Departure from Design Standards DDS-621

SUBJECT: **Departure from Design Standards Application No. DDS-621**

TEMPLE OF PRAISE INTERNATIONAL CHURCH

SITE PLAN

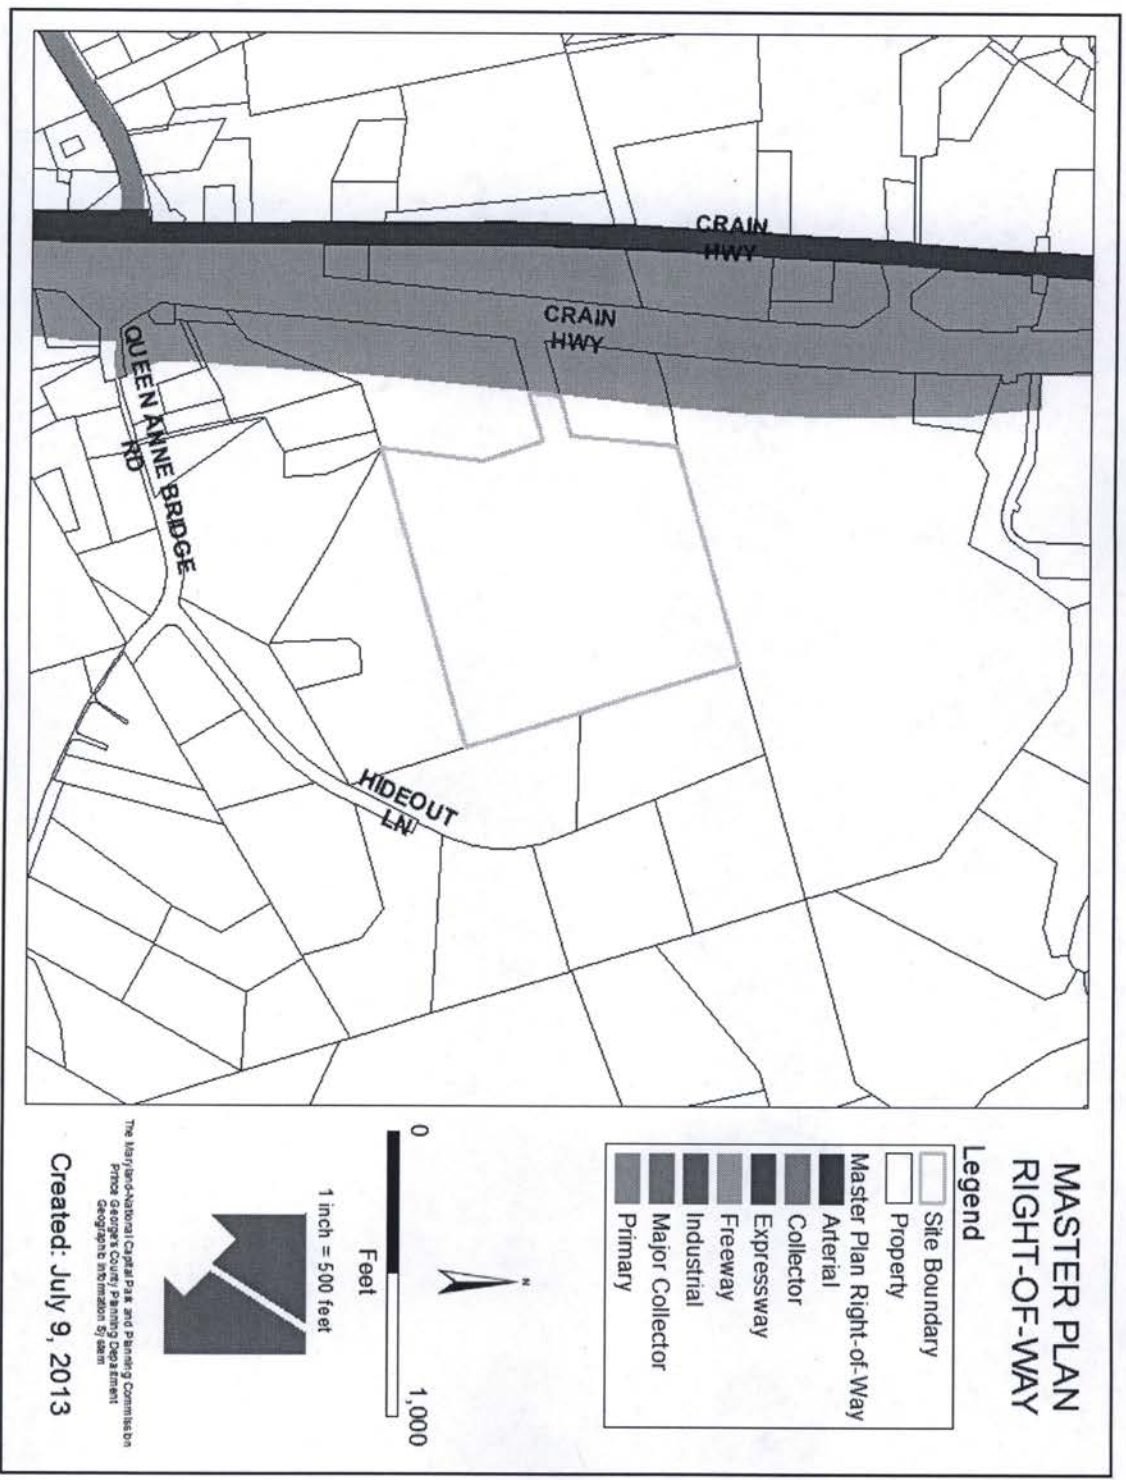
- 1.) Per Subdivision. HOLD. It appears the site will consist of two Parcels, Parcel 148 and Parcel A per Plat 105-47. Need to indicate the boundaries of both Parcels. Need to contact Martin Grigsby at 301-952-5597 for more information on this. *1/7/13 – Per revised plans bearing and distances are incorrect. Label conservation easements, include bearing and distances as shown on Plat 236-77, and label unmitigated 1.5 safety factor line. For additional information please contact Brenda Otto at 301-952-5243 for additional information. 03-21-13 Comment Stands. Again the bearing and distances around the perimeter of the property lines are incorrect. These need to be revised to match the Plat. Also the correct bearings and distances are demonstrated on the TCP plan if that helps. BEL.* 03-22-13 Comment Satisfied. Site plan matches Plat 236@77. BEL

- 4.) Need to submit a site plan in conformance with Section 27-254 of the Prince George's County Zoning Ordinance. The site plan submitted is inadequate for review. *1/7/13 – Per revise plans this comments is still outstanding. The plans do not provided any building dimensions, building setbacks, proposed use, correct legal description, zoning of property, general notes, etc. Please refer to the requirements set forth in Section 27-254 of the Zoning Ordinance as well as the Residential Regulations Tables in Section 27-442 of the Zoning Ordinance. 03-21-13 Comment Stands. Again need to demonstrate all requirements for Section 27-254 and 27-442 on the site plan. All requirements must be demonstrated on the site plan only within a General Notes or Site Notes Section. BEL.*

- 6.) The correct legal description and acreage per Record Plat 236-77 must be provided on the site plan. **03-21-13 Comment Stands. There should be a note on the plan within the property demonstrating "Parcel 1, 22.1407 Acres, 964,448 Sq. Ft."** BEL. **06-27-13 Comments Stands. Again need the property description shown within the boundary of the Parcel. BEL. 07-03-13 Continue Hold. BEL**

- 8.) A loading schedule must be provided on the site plan. Churches between 10, 000 and 100, 000 s.f. of gross floor area require one loading space. The loading space and its access must comply with Sections 27-577 thru 27-581 of the Zoning Ordinance. A departure will be required if the loading space or its access is within 50 feet of any Residential Zone. **03-21-13 Comment Stands. The access to the loading space must have a 50' setback from all properties that are adjacent to residentially zoned property. It appears the lots access from Crain Hwy. with will not have the required minimum of 122' width which would include the 50' setback on each side of the driveway and the required 22' width driveway access. You will need to apply for a Departure from Loading Space (DPLS) to not have to provide a loading space on the site at all or a Departure from Design Standards (DDS) which will allow the loading space to be located on the site without having to meet the required setbacks. You will need to contact Edward Holley at 301-952-3215 for more information on this process to include application, fees and time frame. This is one of the reasoning for not allowing a pre-review on permits. Also the**

- 9.) The parking schedule must provide the dimensions and types of all proposed parking spaces. *03-21-13 Comment Stands. The parking tabulation needs to be corrected. The site appears to provide 650 seats but the note under type of use is requiring 600 seats, the ADA requirements is 6 not 7, the ADA car accessible spaces must be delineated at 13'x19' (to include a 5' aisle) and the van ADA accessible spaces must be delineated at 16'x19' (to include a 8' wide aisle), access aisles may be shared between two handicap spaces. Need to clarify. BEL. *06-27-13 Comment Stands. BEL. 07-03-13 Continue Hold. BEL**

- 12.) The parking schedule must be revised to reflect the correct method of calculating the required number accessible parking spaces. The number of required accessible parking spaces is determined by the number of spaces provided in the parking lot, not by the number of seats. One out of every 4 accessible parking spaces must be a van space. *03-21-13 Comment Partially Satisfied. See updated comment #4 above for minor corrections. BEL. *06-27-13 Comment Stands. BEL. 07-03-13 Continue Hold. BEL**

- 15.) The van accessible parking spaces must be labeled as such on the site plan. *03-21-13 Comment Partially Satisfied. Need to delineate the dimensions on the car and van accessible spaces for clarification of each. BEL. *06-27-13 Comment Stands. BEL. 07-03-13 Continue Hold. BEL**

- 16.) The access as well as all drive isles must be dimensioned on the site plan in accordance with Sec 27-560 and 563 of the Zoning Ordinance. *03-21-13 Comment Stands. Need to demonstrate this on the site plan sheet. BEL. *06-27-13 Comment Partially Satisfied.**

- 17.) ~~The height and type of all proposed fence must be provided on the site plan. 03-21-13~~
Comment Stands. Need to demonstrate this on the site plan. Also the required screening around a dumpster must be 6' high Board on Board and a detail must be shown on the Site Detail Sheet. BEL. 06-27-13 Comment Satisfied. Screening for dumpster will be 6' high board on board fence and all other fencing labeled. BEL

LANDSCAPE PLAN

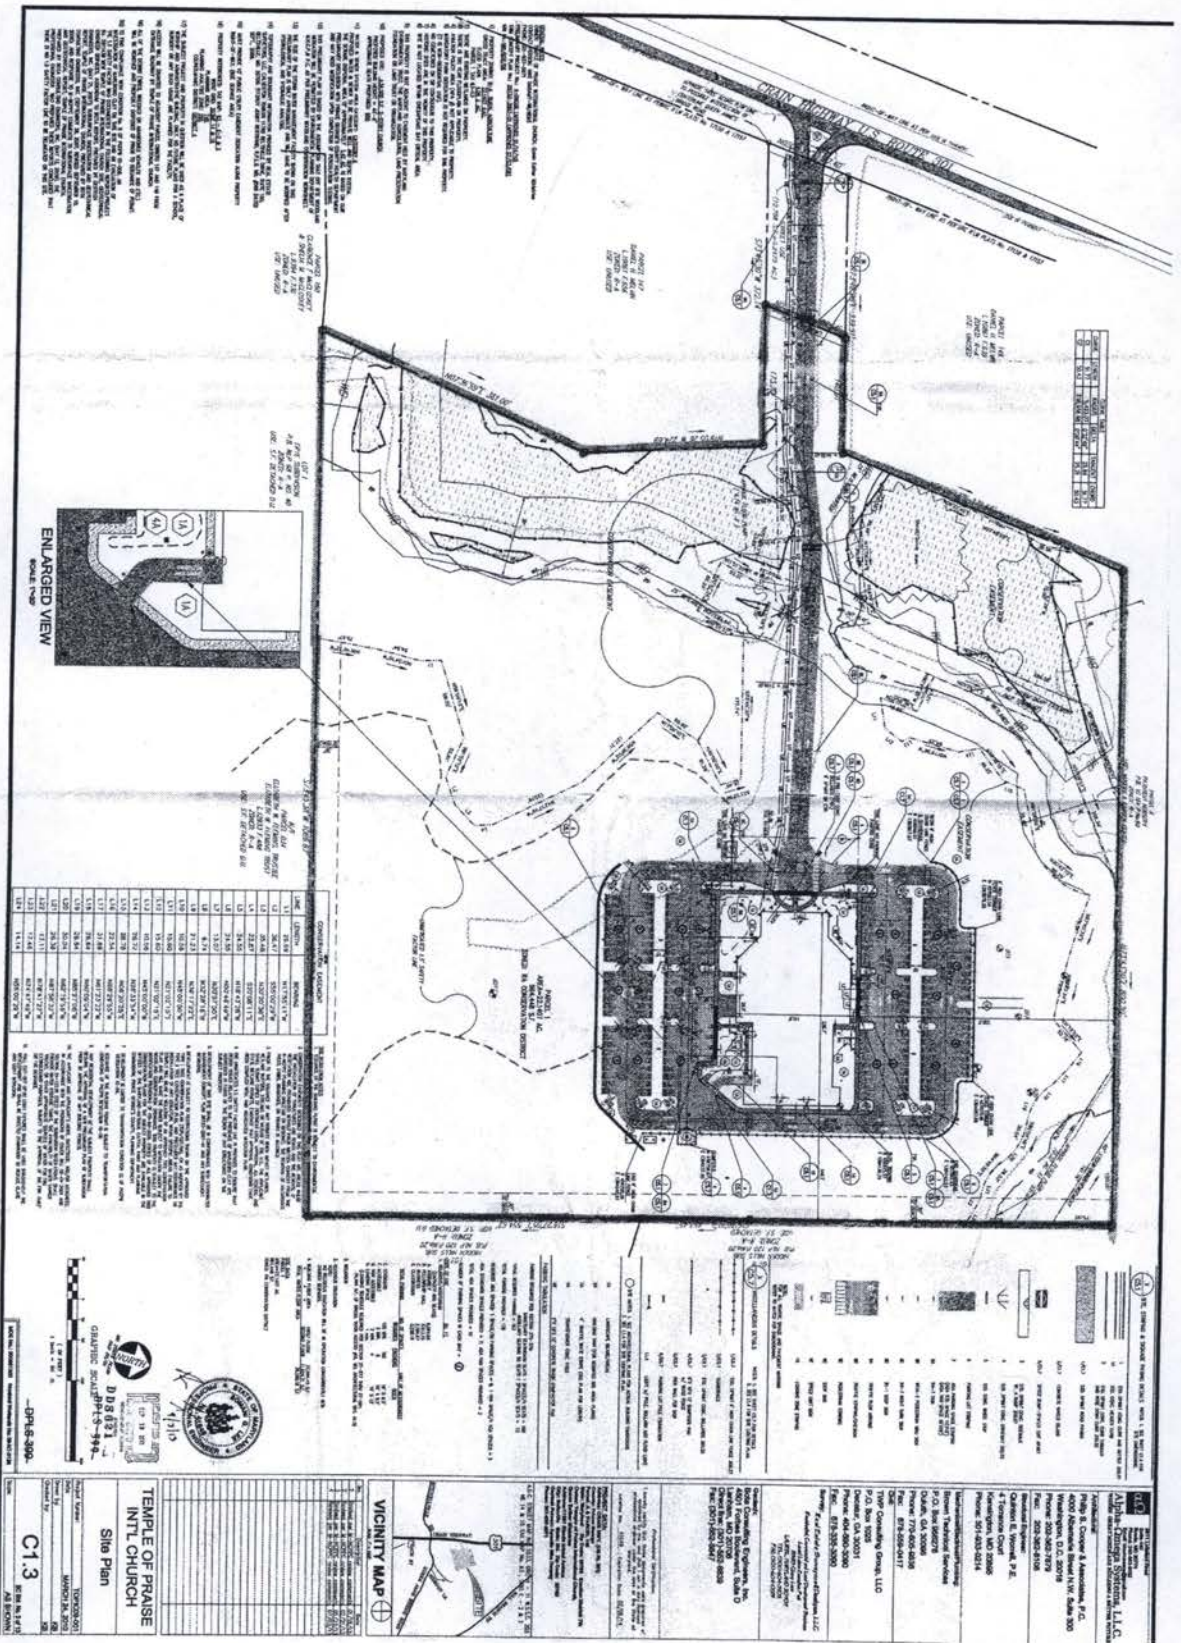
- 21.) Please clarify the linear feet calculation in the schedule for 4.2-1. Driveway openings are excluded from this calculation. Also the landscape plan must label the proposed landscape strip as such and provide the width. The plan must clearly show how option is 2 is met. 03-21-13 Comment Stands. No schedules are shown on the Landscape Plans. However sheet 4 of 6 is missing. Also need to clarify the width of each landscape yard for Section 4.2 and 4.3 along with the Driveway dimension for clarification on linear footage. BEL. 06-27-13 Comment Stands. No landscape plan submitted. BEL. 07-03-13 Comment Stands. It appears the linear footage for 4.2 is for 76' after subtracting the entrance, if this is the case you will be required to provide 3 shade trees and 22 shrubs per Option #1 in the Rural Tier. Also it appears there is a PUE within the strip, per Option #1 you cannot plant within the 10' PUE and the landscape strip must be shown at 20' wide. Therefore you will need a total of 30' at the front property line for the 4.2 of which 10' need to be shown as the PUE and the other 20' needs to be shown as the landscape strip and all plant units must be within the 20' strip. If any of these requirements cannot be met then Alternative Compliance will be required. You will need to contact Lillian Fairley at 301-952-3296 for more information on this. BEL

- 23.) Separate schedules for each property line for Section 4.7 of the Landscape Manual must be provided because there are different uses with different impacts that abut the property. For example, a C bufferyard is required along the drive way adjacent to the vacant uses on Parcels 147 and 149. It does not appear the minimum 30 foot landscape yard is provided adjacent to Parcel 149. Alternative Compliance may be required. 03-21-13 Comment Stands. No schedules are shown on the Landscape Plans. However sheet 4 of 6 is missing. BEL. 06-27-13 Comment Stands. No landscape plan submitted. BEL. 07-03-13

Comment Updated. Buffer Yard #1 need's to demonstrate a 30' landscape strip and is required 171 Plant Units in the Rural Tier. Buffer yard #9 need's to demonstrate a 30' landscape strip and is required 210 Plant Units in the Rural Tier. There is no allowed reduction in the Rural Tier. Need to update Section 4.9 for the plant units per this comment as well and revise sheet LI.1 to add the required note from Section 4.9 schedule #4 to the plan. If any of these requirements cannot be met then Alternative Compliance will be required. You will need to contact Lillian Fairley at 301-952-3296 for more information on this. BEL
